Appendix L: Aboriginal Heritage Response to Submissions Report

Re: Rye Park Wind Farm – Response to Submissions Cultural Heritage

Rye Park Windfarm Submission Comments

Figure 1. Location of Pudman Reserve and residence.

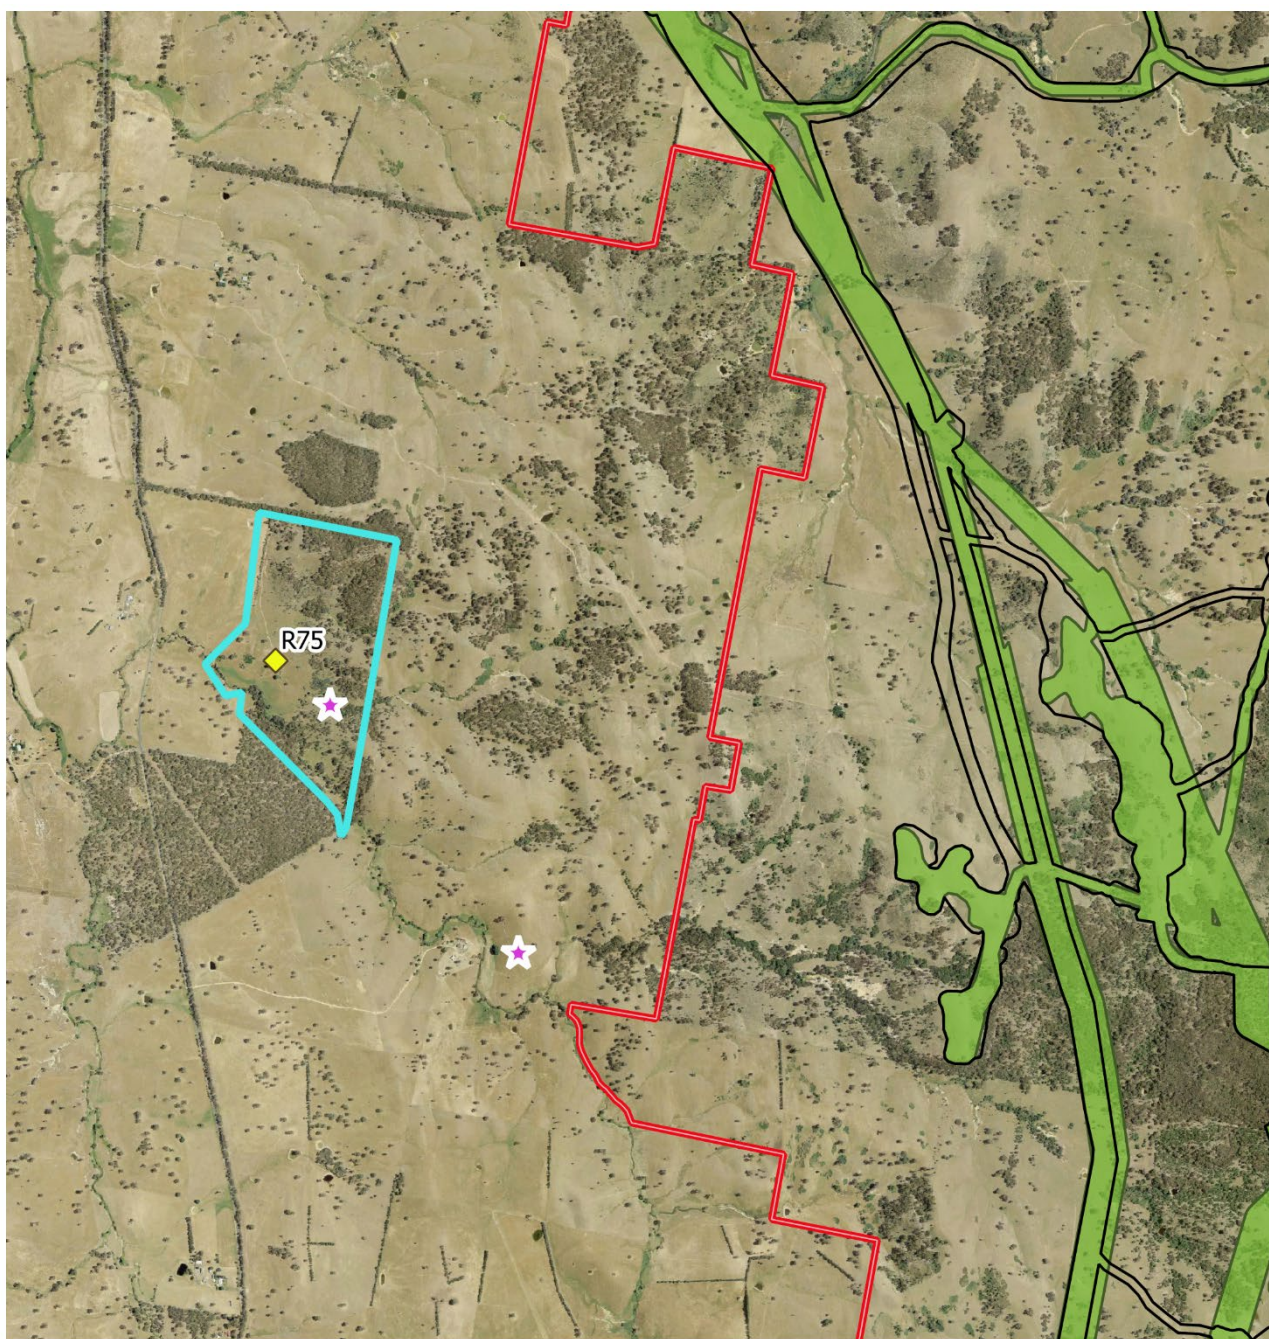
The questions about the landowner's property referencing residence R75 indicates that this property is the former Pudman Aboriginal Reserve. The eastern boundary of the property is approximately 1.4 km from the western boundary of the Rye Park Wind Farm project area and therefore is not within the proposed footprint area (see Figure below). Surveys for the original assessment and the Modification were undertaken on a precise footprint, and the survey was restricted to this footprint. No wider surveys were necessary or undertaken and thus this property and the former reserve were not required to be surveyed. It is likely that there are many other Aboriginal heritage sites in the region, including on the property in question but they did not need to be assessed under the current proposal design as the Project Area does not cover these properties.

The information presented in this submission (Submission S-126210) is of interest to the project for context on the history of Aboriginal occupation and use of the broader landscape and continuing connection to the area. However, NGH do not believe it materially changes the findings of the assessment of impacts to Aboriginal heritage within the project footprint.

The consultation process through both the NSW Archaeology and NGH heritage studies provided many opportunities for local Aboriginal community members to identify areas of cultural concern. None mentioned the presence of Pudman Reserve and none identified this as an area of concern. The quoted comment in the response to headstones and burials was not made in either the NSW Archaeology report or the NGH report and therefore we are not aware of what this quote refers to. NGH also notes that the Reserve is at least 1.4 km outside the development envelope, and therefore not impacted and not considered in the assessment of impacts.

Figure 2. General location of Historic locations.

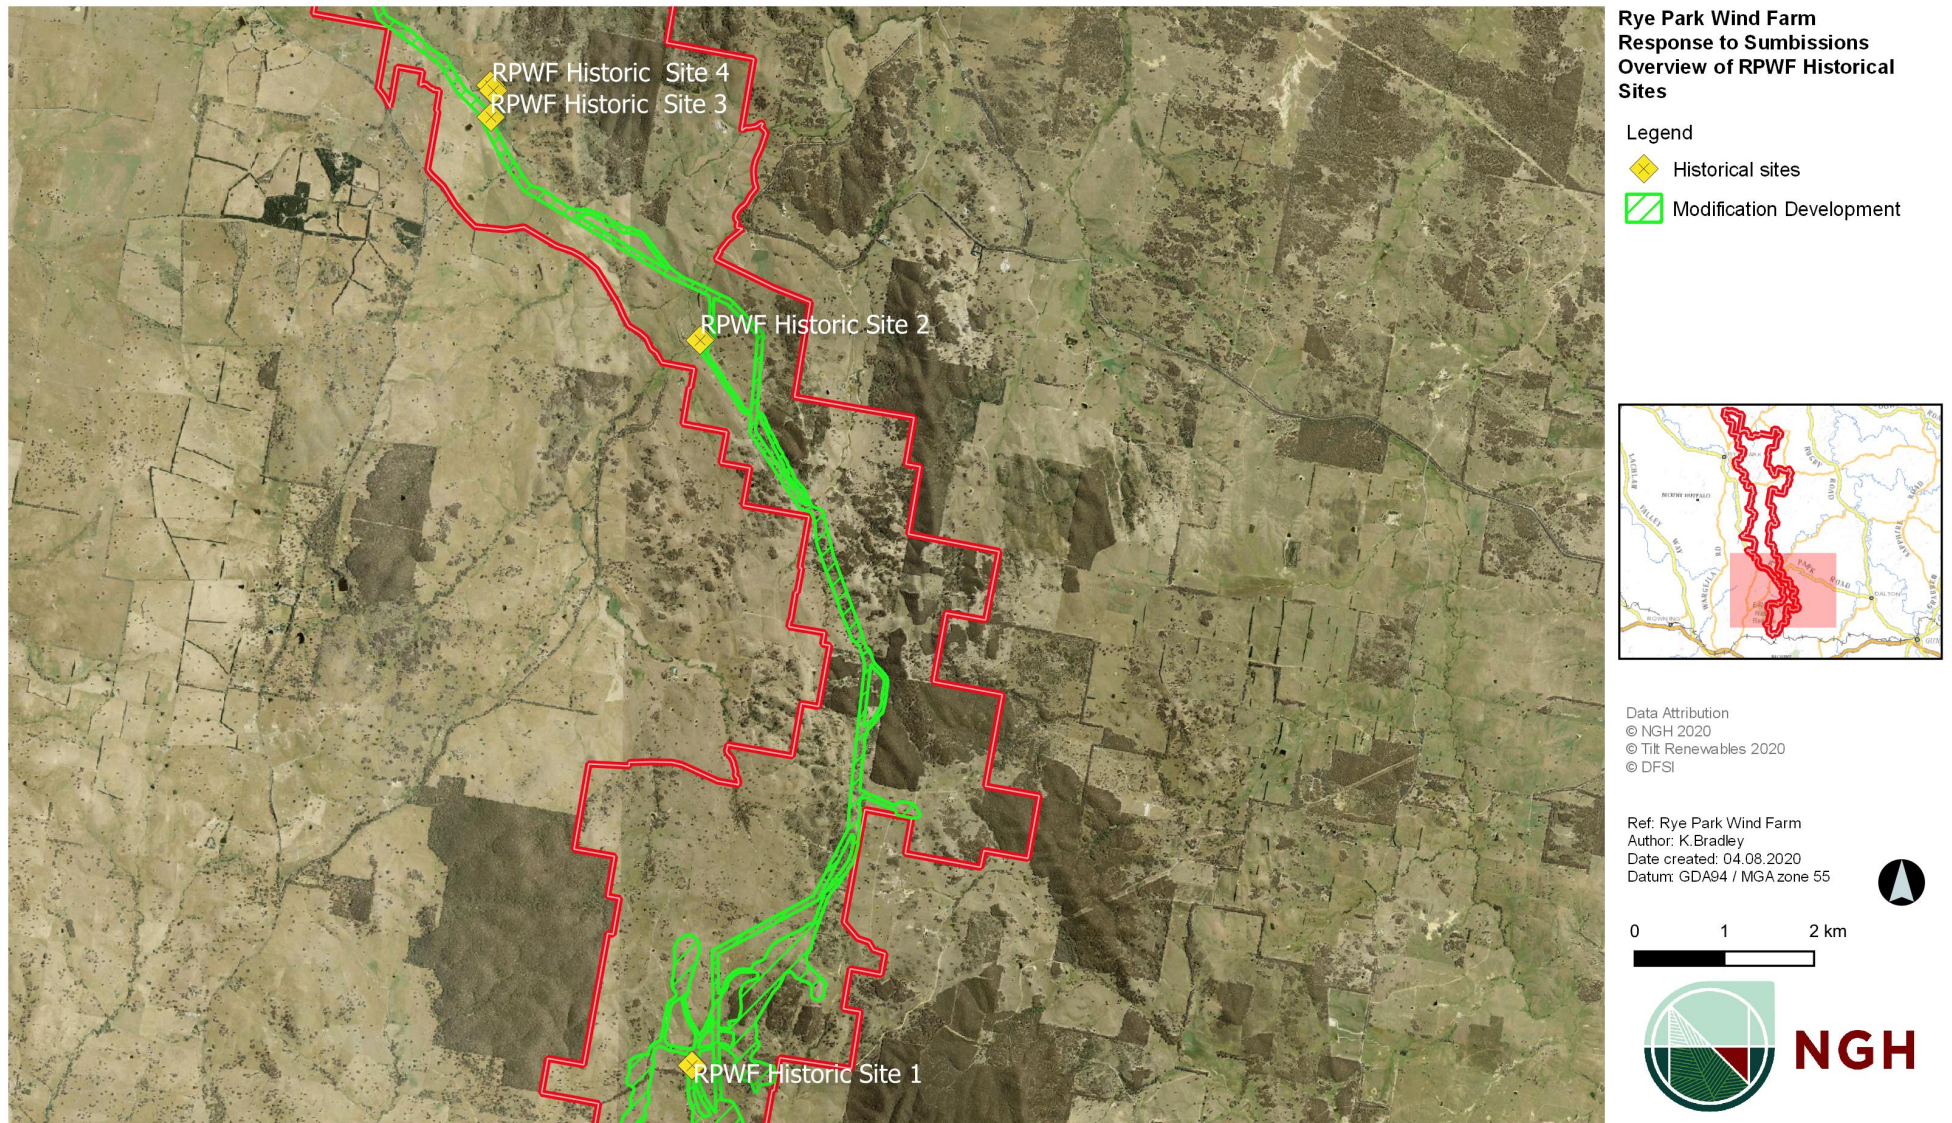
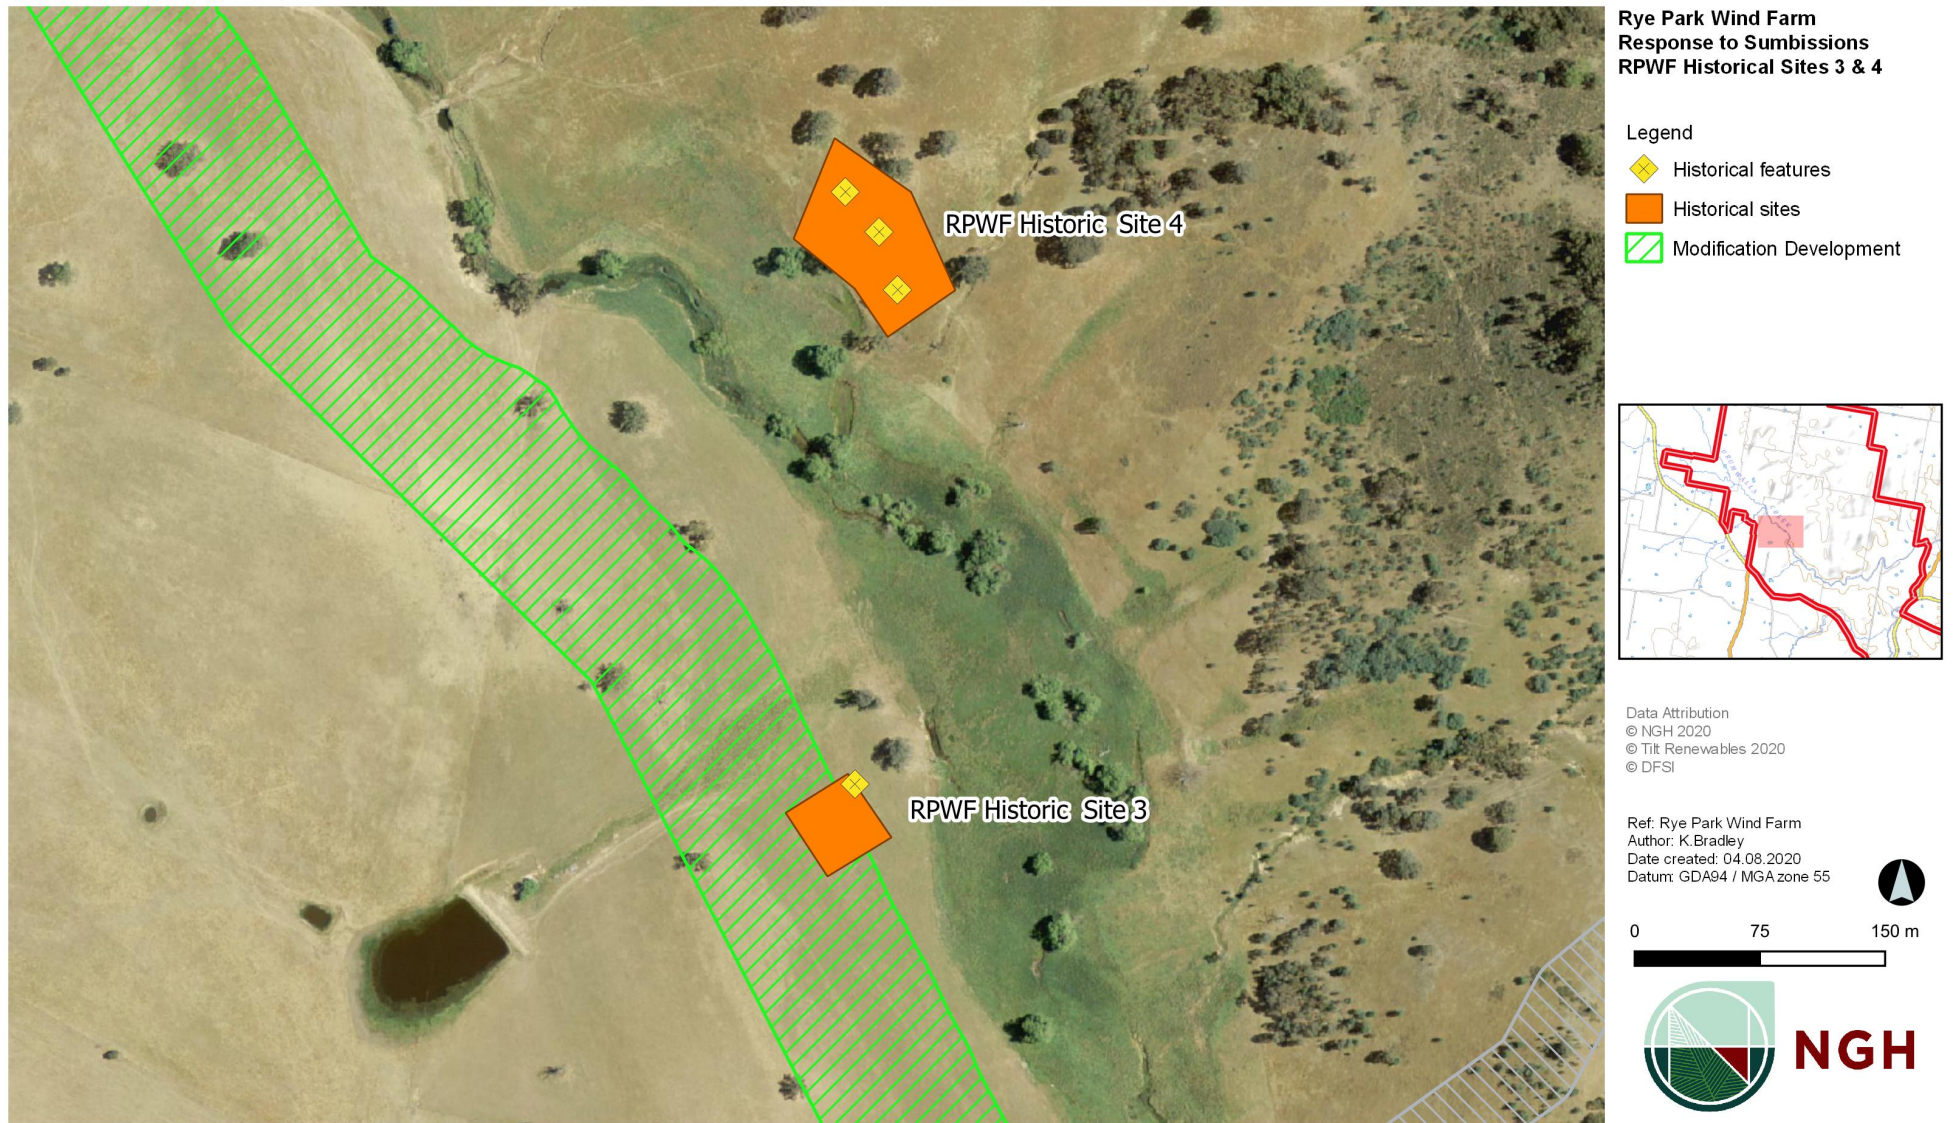
The presence of eight potential historic heritage feature within four locations within the proposal area was identified during the Aboriginal heritage survey and it was recommended that appropriate management be undertaken if the items were to be impacted. NGH believes that a Statement of Heritage Impact (SOHI) would be advisable, as indicated by Heritage NSW, if the items were impacted. The items in question are shown in Table 4 and their locations are shown in Figures 2-5. Only three of the features are within the proposal footprint but it is considered that they, and any associated archaeological material, could be avoided by the Wind Farm.

RPRE have confirmed that if these identified places are to be impacted, then further assessment would be undertaken. The results of such an assessment would then identify the relevant impacts and appropriate management measures to either avoid impact or mitigate impact.

No areas of historical archaeology were identified during the field surveys. However, if during further assessment of the historic places, archaeological material was detected or suspected, NGH and RPRE would undertake the necessary actions to examine the significance of such material. Where possible, such material would be avoided by simple redesign of the footprint but if this were not possible, further assessment and mitigation in the form of excavation may be warranted.

Figure 6. Location of Additional Areas requiring Aboriginal heritage survey.

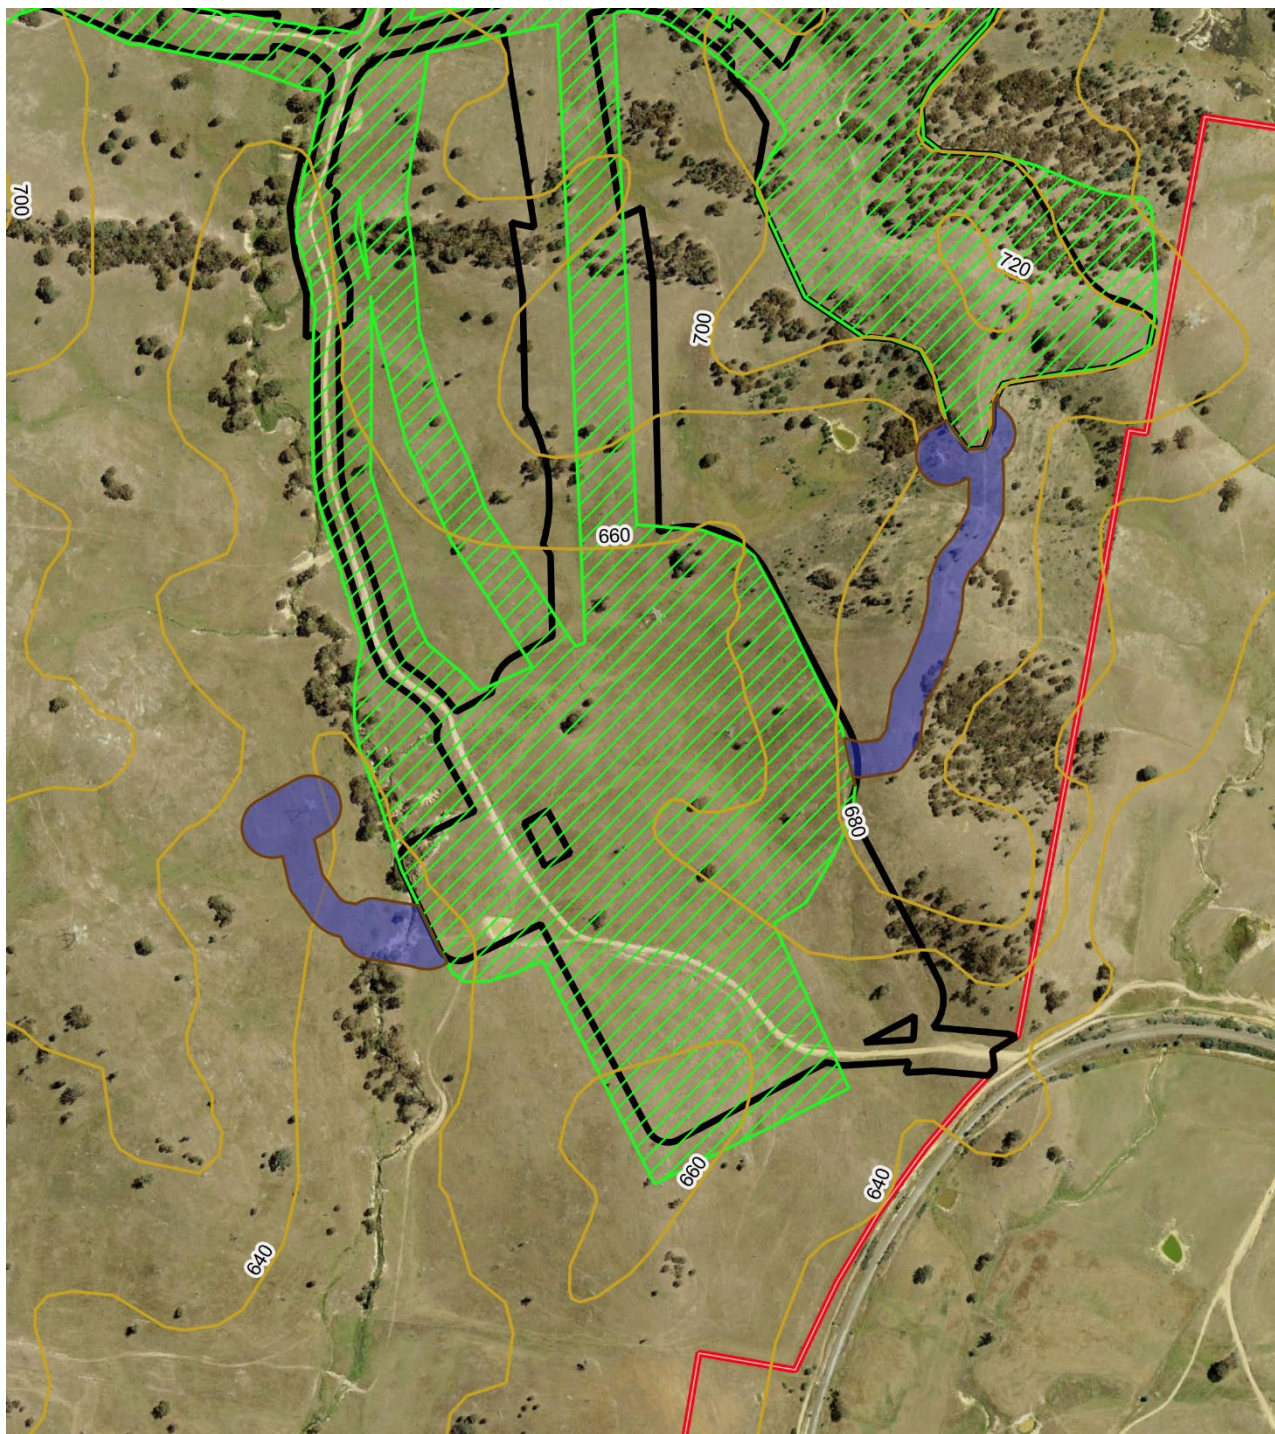
Since the most recent fieldwork was completed that will be subject to an Addendum to the Modification ACHA report, a further small change has been made to the footprint that will require additional heritage assessment and survey. The area is shown in figure 6 below. This change is to accommodate a variation in the placement of transmission line poles.

Rye Park Renewable Energy has committed to undertaking the survey prior to the construction of the project. It is anticipated that the registered Aboriginal parties involved in previous surveys would also be afforded the opportunity to participate in the survey of these areas. A report detailing the results would be completed and added to an updated Addendum outlined in the section above. The RAPs would be provided an opportunity to comment on any findings and recommendations in accordance with the Heritage NSW *Consultation Requirements* and the report would be submitted to DPIE.
